UNITED STATES
NUCLEAR REGULATORY COMMISSION
WASHINGTON, D. C. 20555

MAY 16 1980

Enclosure:
Rpt of the Tailings Management
Evaluation of the Proposed
Mt. Taylor Project

REPORT OF THE TAILINGS MANAGEMENT EVALUATION OF THE PROPOSED MT. TAYLOR PROJECT

FIGURE 11-2

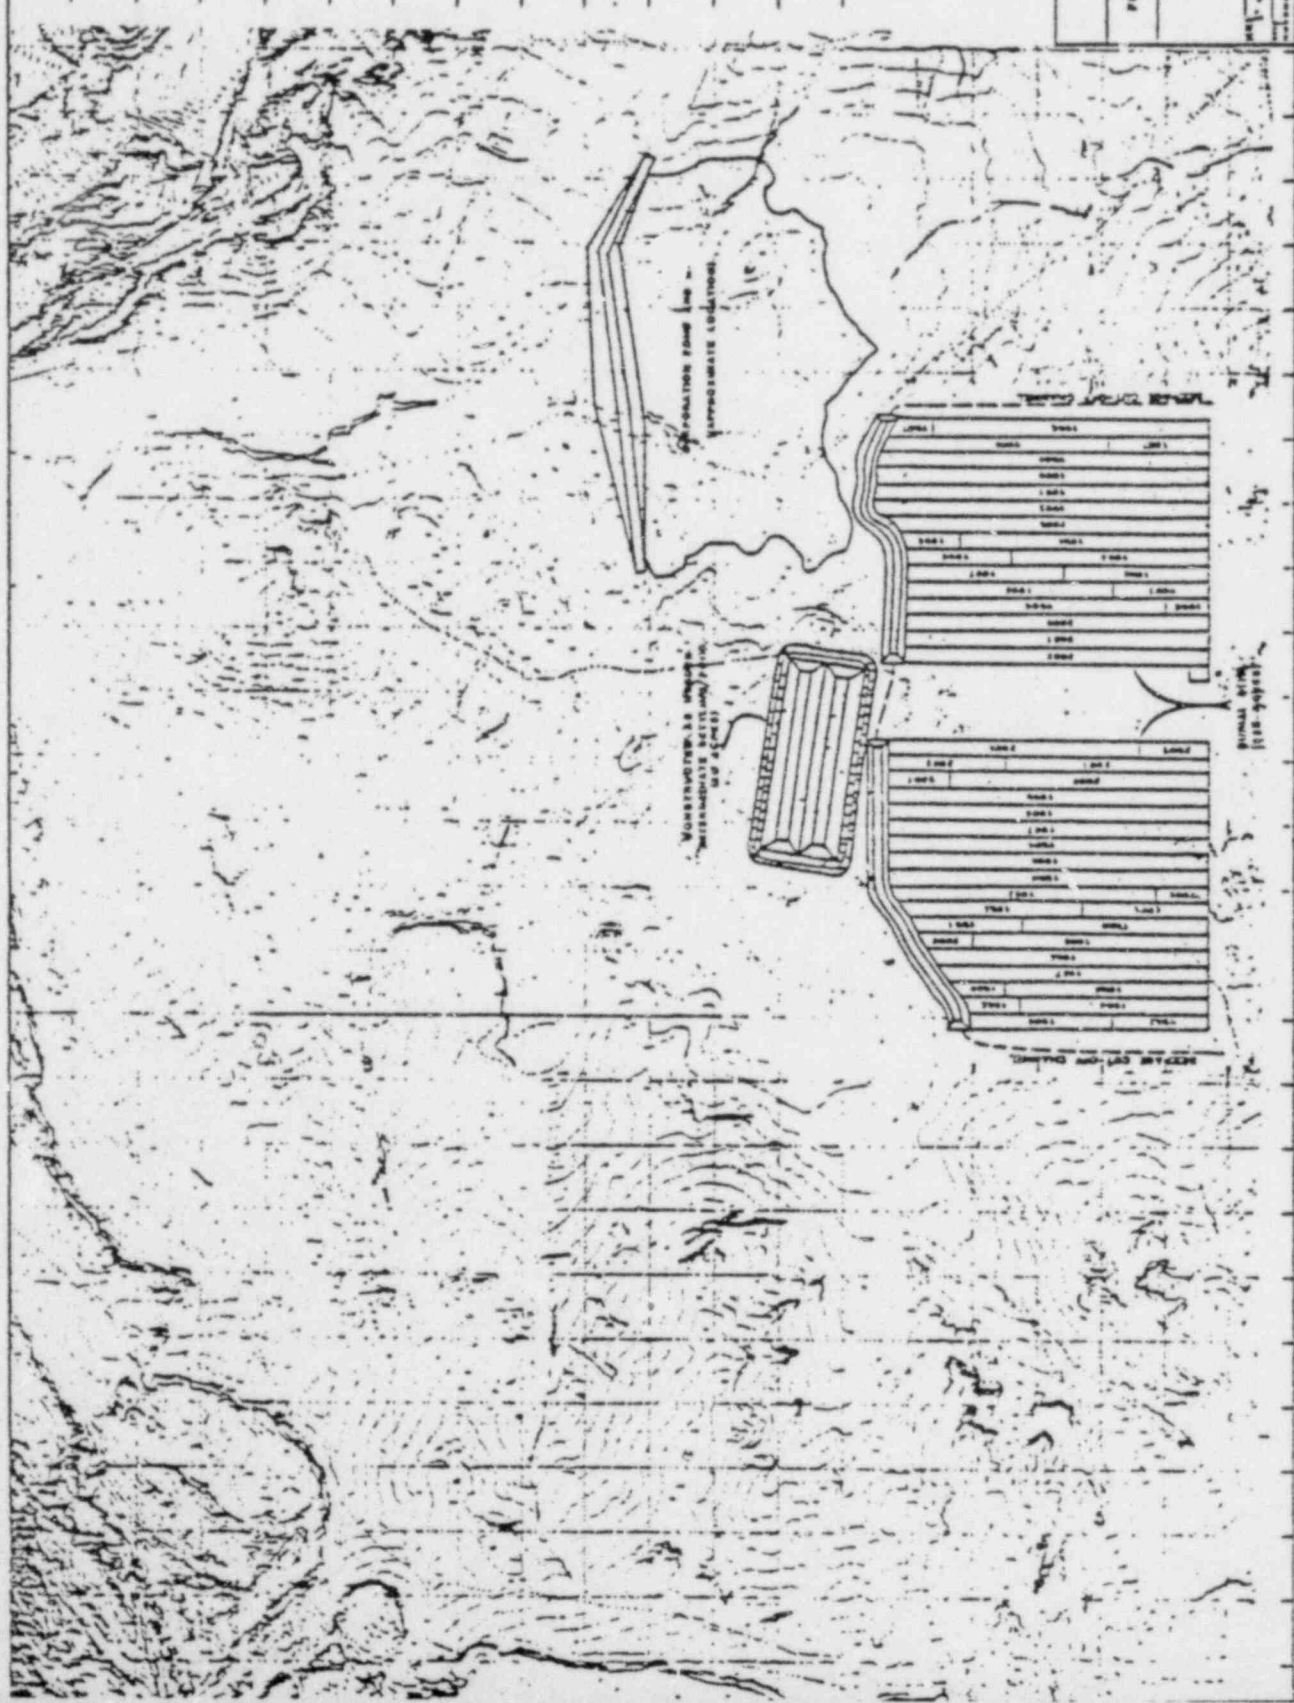
Figure II-1 (of Ref. 1) is an "artist's conception" illustration showing the tailings burial system described above. Figure II-2 (of Ref. 1) shows the location and orientation of the burial trenches in La Polvadera Canyon. The most recent studies by Gulf showed that the evaporation pond required may encroach on the southeast corner of the trench area and some minor adjustments in the trench system layout may need to be proposed as a result of final design studies. Table II-1 (of Ref. 1) contains the liquid and solid waste production rates used by Gulf in developing the proposal.

In December 1979, Gulf submitted to the NMEID a radically different tailings management system proposal and a tailings management alternative study. The revised and current proposal is essentially the dragline burial scheme under consideration. The most recent version of that proposal is described in the revised Groundwater Discharge Plan. (See Fig. II-2 of Ref. 1)

FIGURE 1

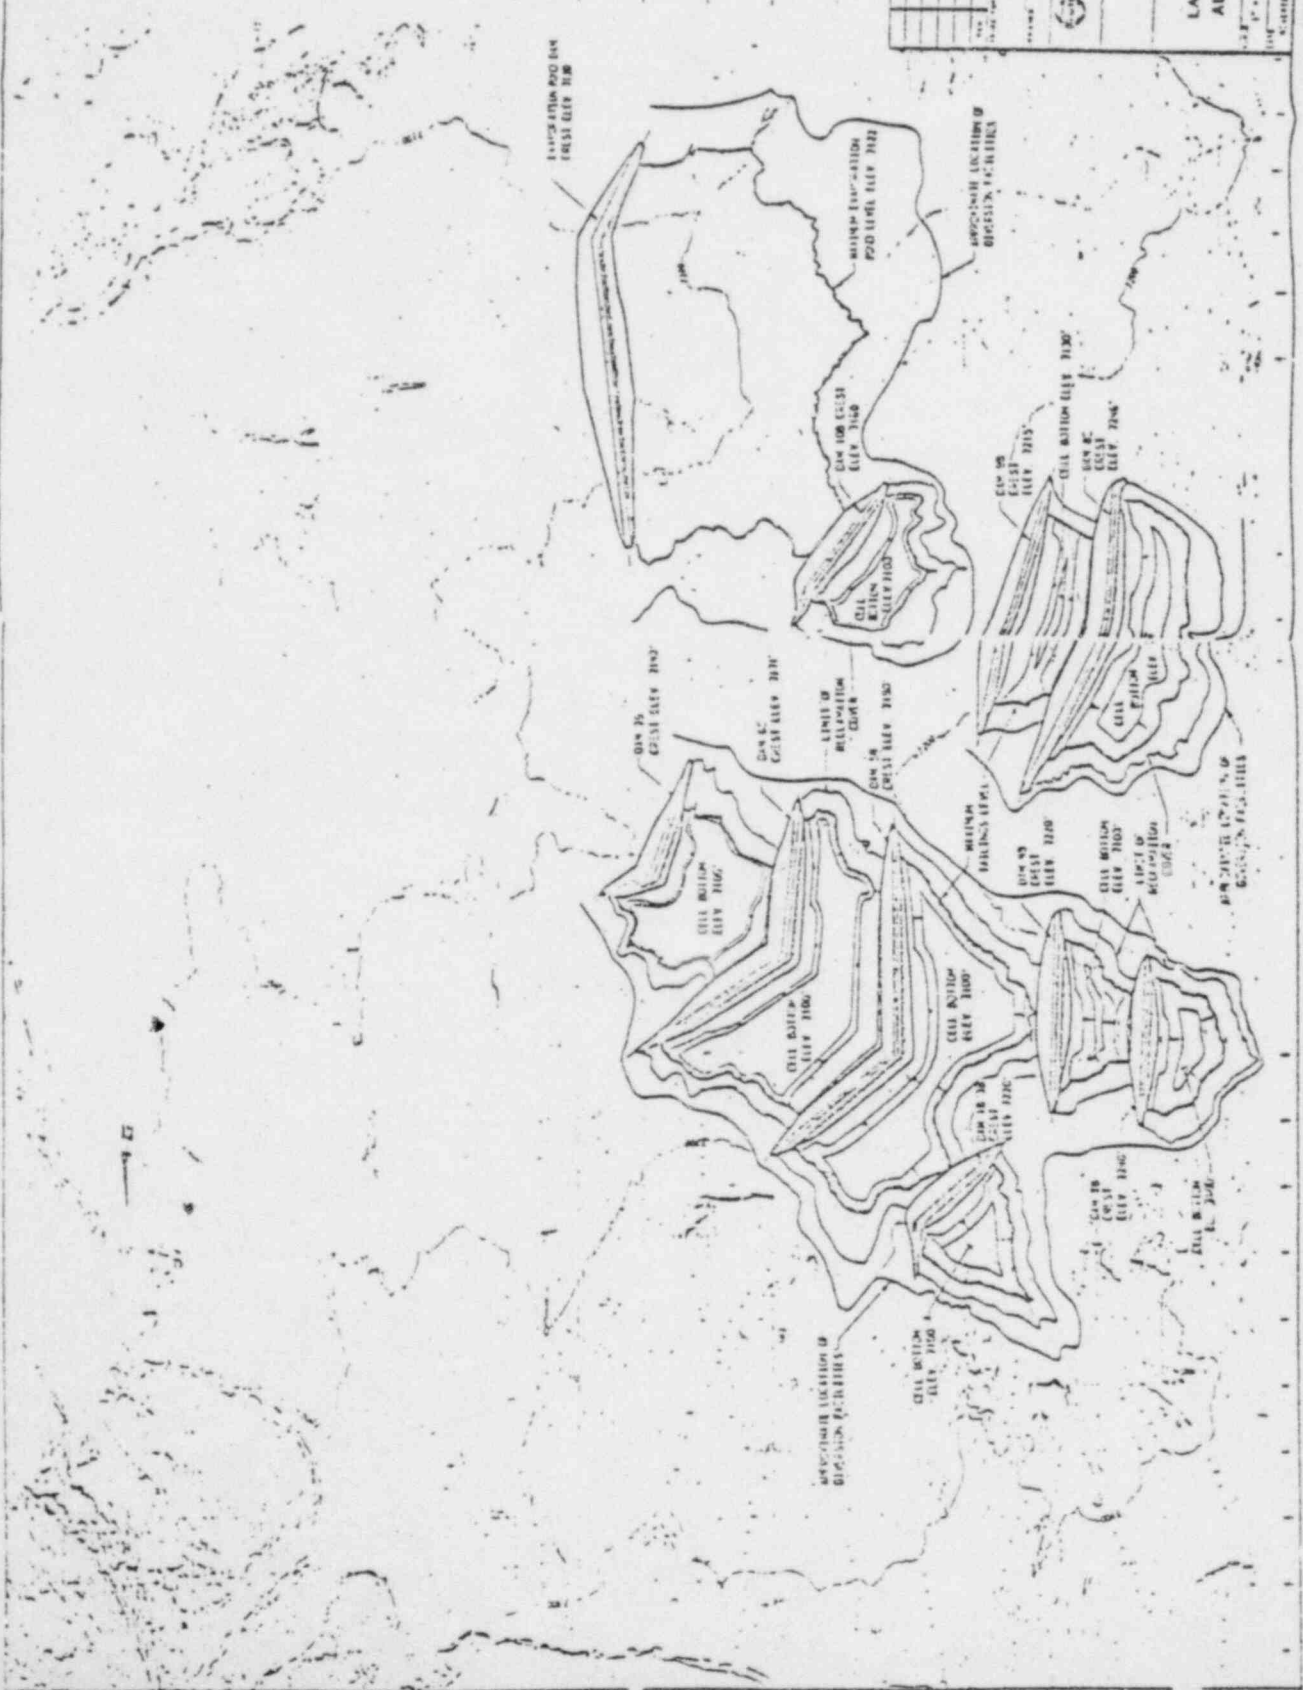
Gulf, NMEID and NRC again visited the site on October 22, 1979 to discuss the proposed tailings management system. In an associated public meeting on October 23, 1979, Gulf gave a presentation of the then-preferred tailings management alternative. The alternative plan consisted of a staged multicell impoundment in the upper reaches of La Polvadera Canyon. The plan would provide for sequential excavation and embankment construction and for staged reclamation. The cell areas would be approximately 20-30 acres each and the embankments would range in height up to about 50 feet. A separate evaporation pond of 120 acres would be provided (Alternative 5B of Ref. 8; see Fig. 1, attached).

The cells would be built down a gradual slope in the Canyon floor. As one cell was being used for tailings disposal, the previously used cell would be dried and the next cell downgradient would serve as an emergency catchment basin. The tailings would be buried as deep as possible, considering practical pit side slopes and isolation from groundwater. The bottom of each cell would be lined with clay to minimize seepage to groundwater and an under-drain would be provided in each cell to allow excess water to be pumped to a lined evaporation pond.

Reclamation would be accomplished in stages. When the cells were filled with tailings and dried out sufficiently, they would be covered with clay, overburden, and topsoil. Exposed embankments would be contoured to gradual slopes and rip rapped to maintain stability and control erosion. Gulf also stated that a dragline burial scheme (the alternative ultimately proposed) was under consideration.

FIGURE III-1
TAILINGS PIPELINE CONTAINMENT BASINS

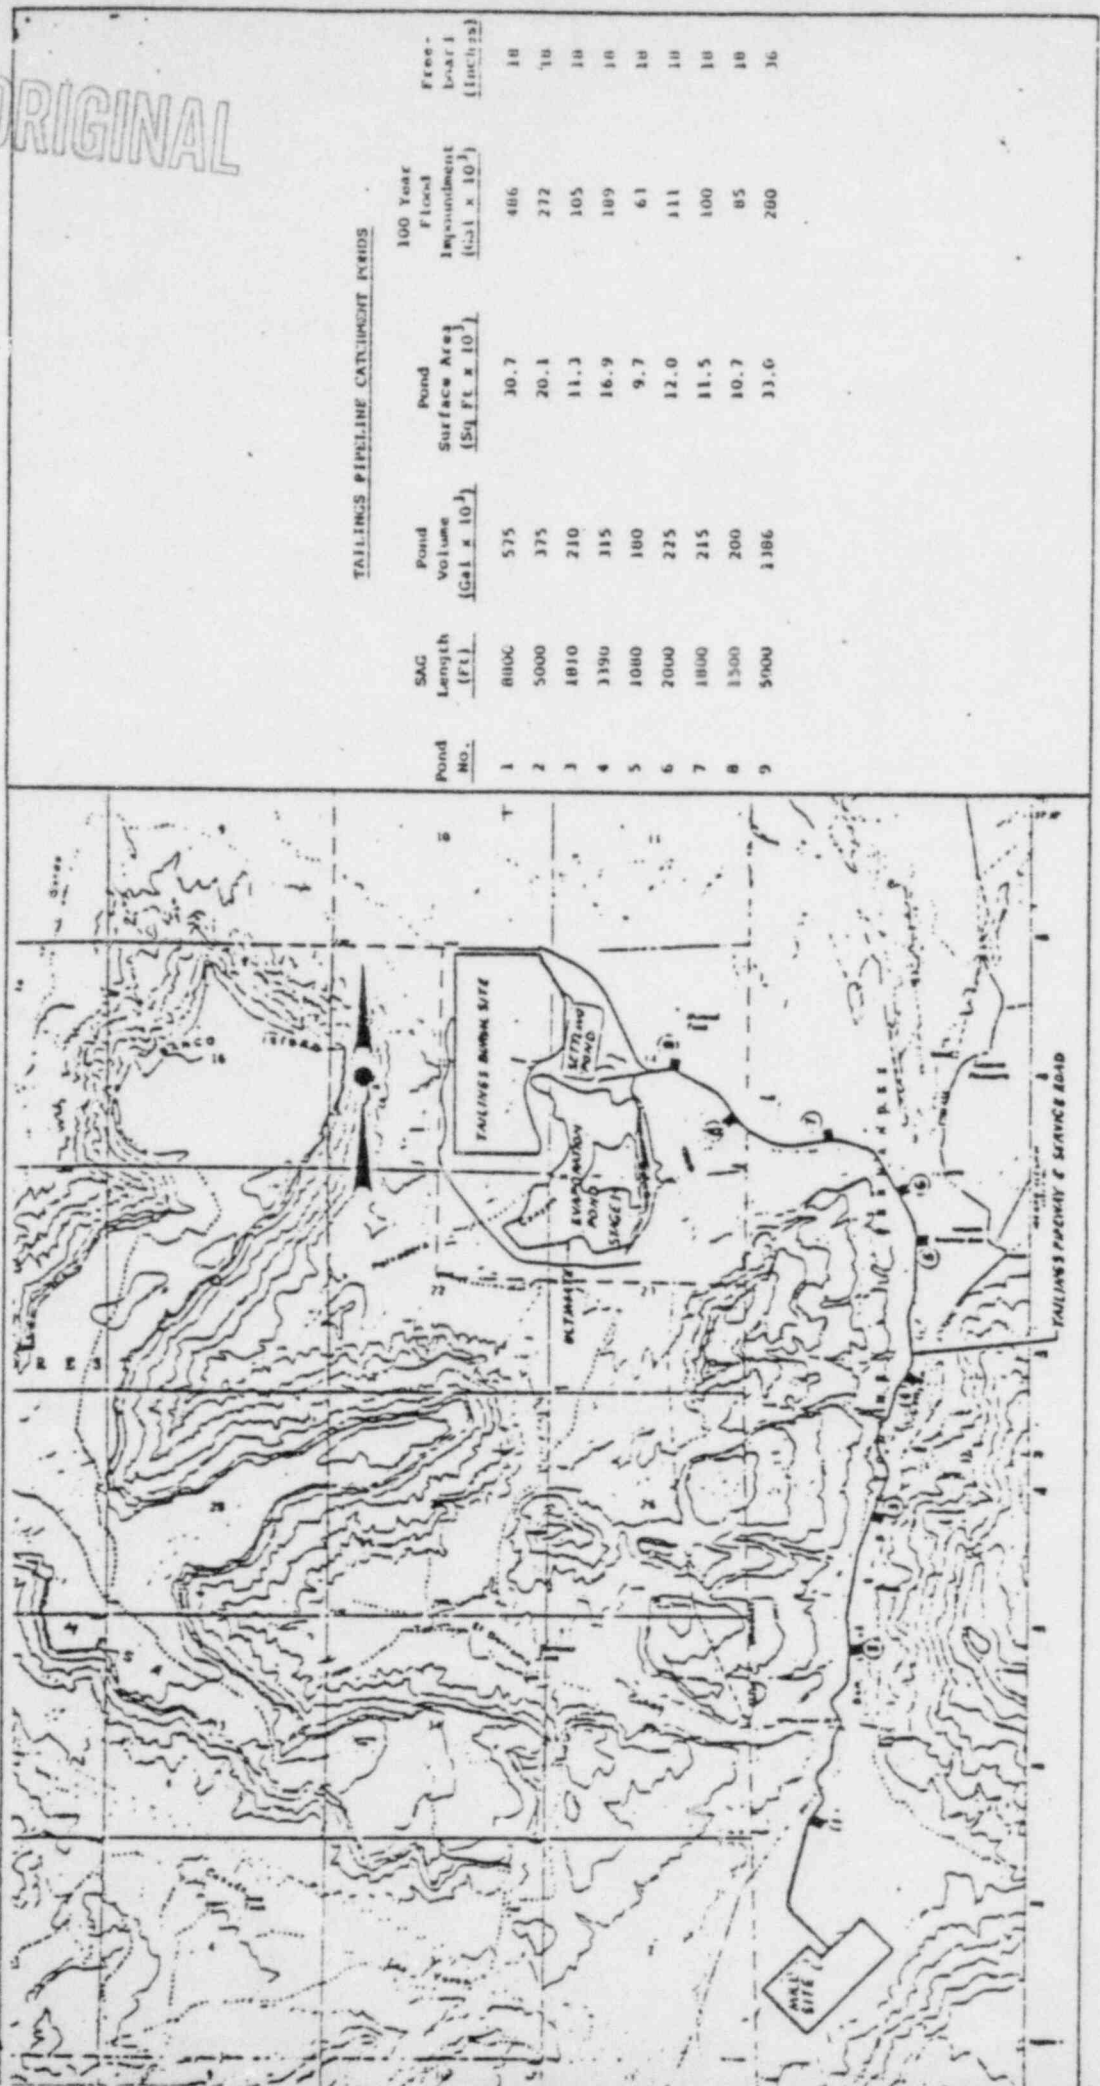
The six-mile tailings pipeline would parallel the San Lucas Canyon from the millsite to the La Polvadera tailings disposal area. The major features of the system would include a diked and lined pipeway elevated to above the 100-year floodplain, nine spill containment basins located at low points along the pipeway, and a service route immediately adjacent to the pipeway. The pipeline would consist of eight-inch, rubber-lined carbon-steel, schedule 30 pipe for transport of the tailings slurry and an identical pipe in the six-inch size for returning decant liquid. Pipeline integrity would be ensured by the "Control and Interlock/Shutdown" system, a round trip visual inspection of the pipeline twice per shift, and a maintenance and inspection program. The layout of the pipeway and catchment system is illustrated in Fig. III-1 (of Ref. 1).

The tailings pipeline should not be a source of seepage except under accident conditions. As an accident analysis is beyond the scope of this evaluation report, only a general recommendation is made that all the details of the design and construction and the written procedures for operation, inspection, and maintenance of the pipeline system be reviewed and approved by the New Mexico Environmental Improvement Division (NMEID) prior to pipeline construction.

Fig. A.1 Schematic Diagram of Existing Groundwater Conditions.

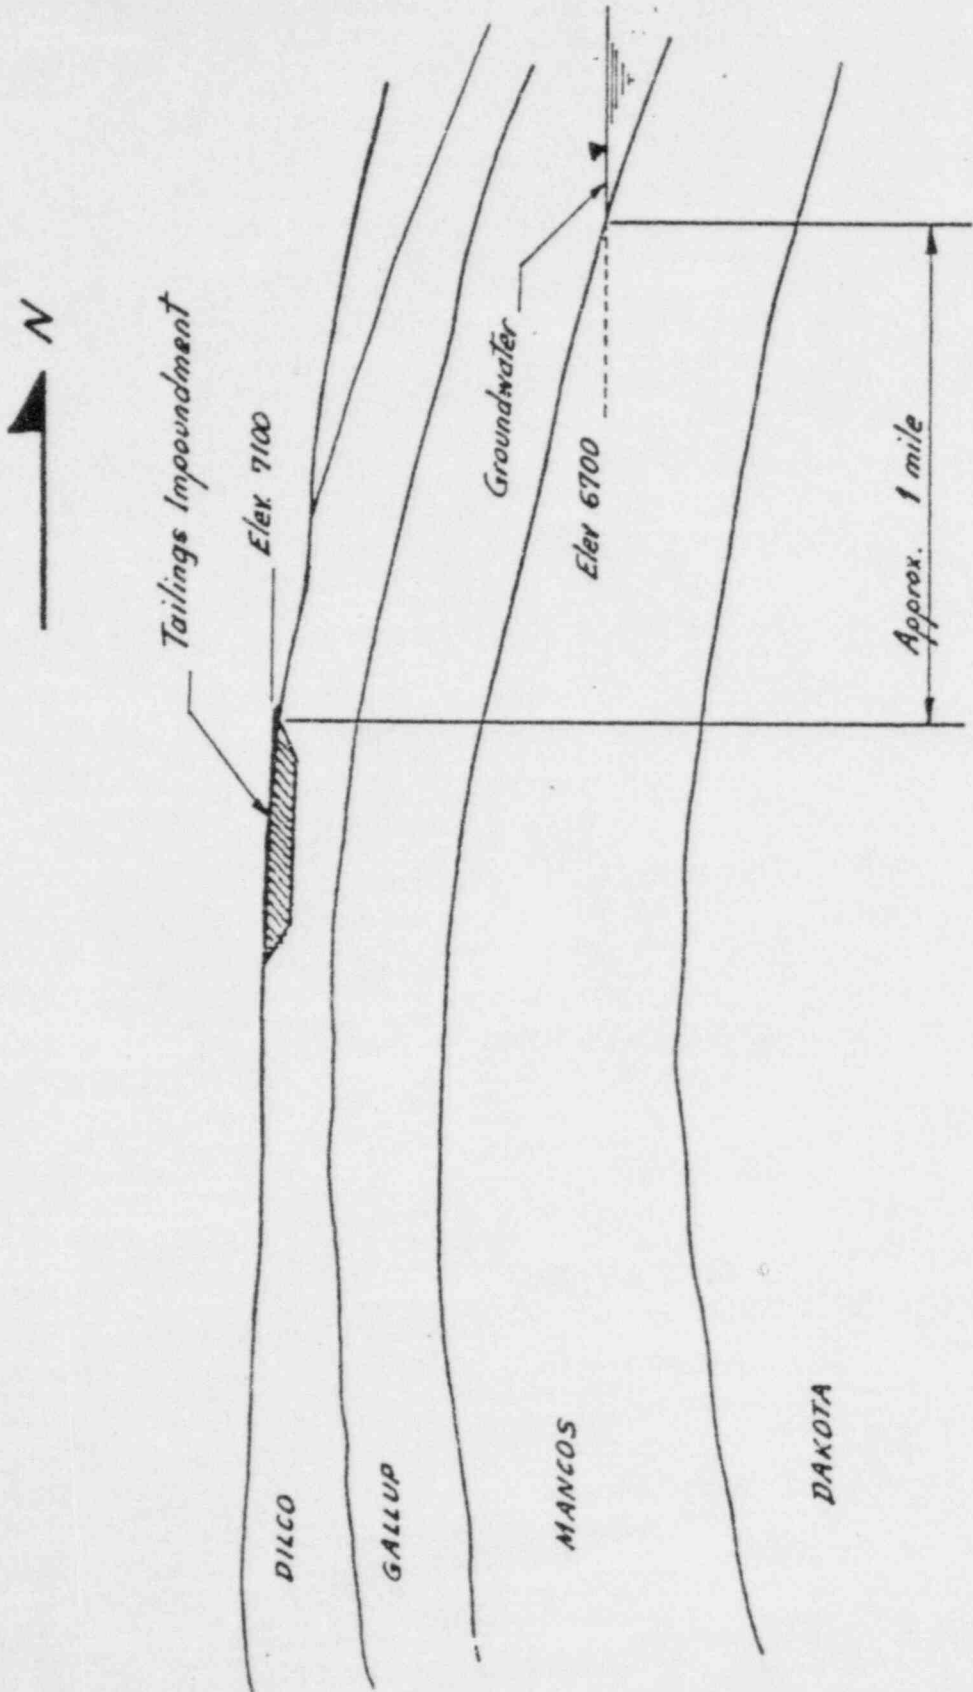
The tailings trenches, slimes sedimentation pond and evaporation pond would be excavated into the Mulatto Tongue Member of the Mancos Shale and the Dilco Coal Member of the Crevasse Canyon Formation. These geologic units are located above the Gallup Sandstone which is separated from the lower Dakota Sandstone, which contains the only groundwater directly at the site, by approximately 1000 feet of the relatively impermeable Mancos Shale (estimated to have a secondary permeability of approximately 0.007 ft/yr).¹ The facilities would be located on the crest of the San Mateo Dome and bedding planes are essentially horizontal at this point. Any seepage through the Gallup Sandstone would spread above the Mancos Shale laterally and would follow the dip of the Mancos. Gulf assumed that any seepage not retained directly beneath the trenches or ponds would move uniformly and radially outward but would not reach the nearest saturated zone in the Gallup Sandstone which is located approximately one mile to the north (Fig. A.1).

Evaporation Pond
 Diagrammatic Cross Section
 Looking North
 Not to Scale

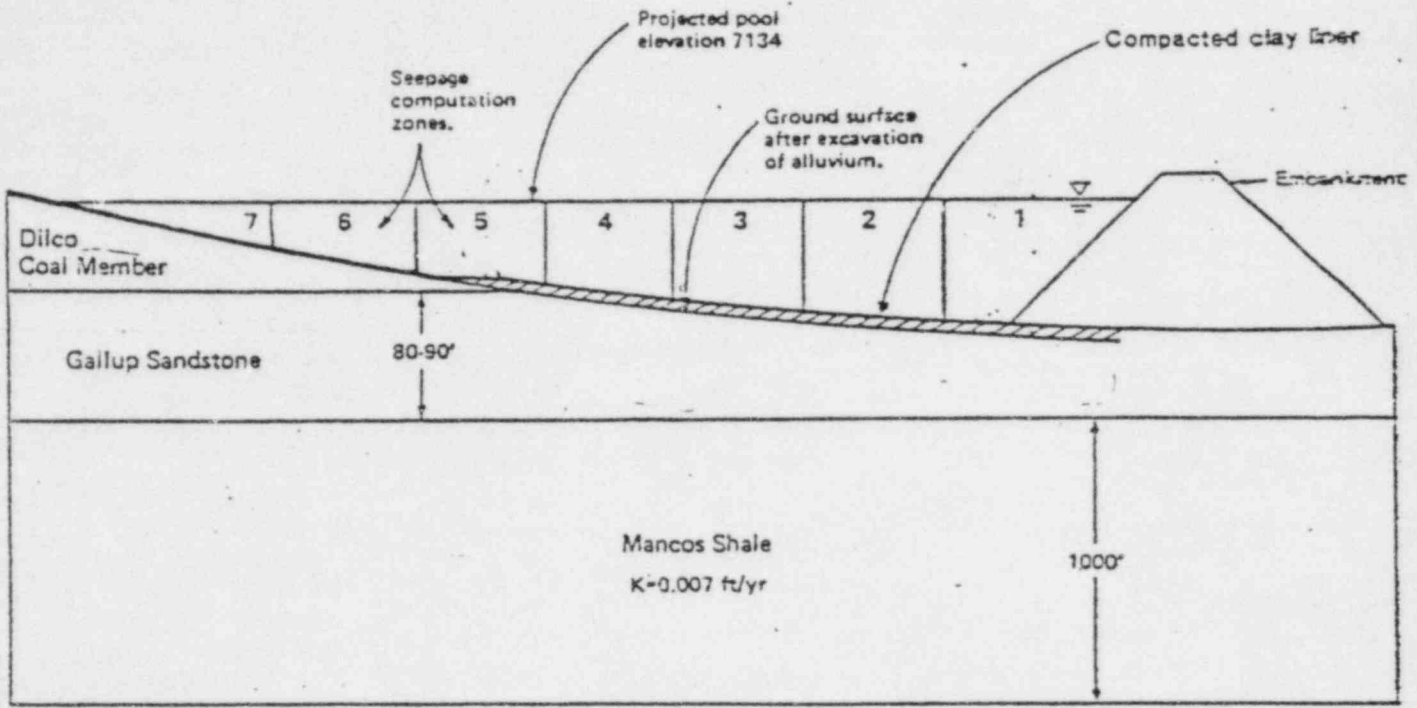
Gulf calculations (see sect. A.2.1, above) show total seepage of 3167 acre-feet would occur over 204 acres versus 2673.4 acre-feet retained storage capacity, and that this is due to seepage exceeding storage capacity by 1049 acre-feet in the 118 acres closest to the embankment. Because seepage from the evaporation pond is controlled by the compacted-clay liner, increasing the permeability of the Dilco unit would not have a significant effect on seepage.

In estimating the actual quantity of liquid that would be available for seepage from the evaporation pond Gulf estimated the net rate of evaporation of liquid from the pond would be 34 inches per year although the mean annual lake evaporation in the area is approximately 57 inches per year and the annual precipitation is approximately 10 to 12 inches per year (per Ref. 1). The 34 inch/year figure is considered appropriate because it takes into account uncertainties concerning actual evaporation from tailings liquids having a low pH and high salt concentration.

Calculations indicate that seepage would be reduced if the thickness of the compacted clay liner were uniformly increased as a function of hydrostatic head and inundation period. For example, liner thickness could be increased in thickness to 10% of ultimate hydrostatic head. A feasible liner alternative would be to substitute a synthetic liner which would ensure a seepage mound is not formed. Other changes to the proposed program which might be considered to reduce seepage include (1) process modifications to reduce the quantities of tailings waste liquids, and (2) relocating the evaporation pond to achieve a better ratio of surface area to storage volume.
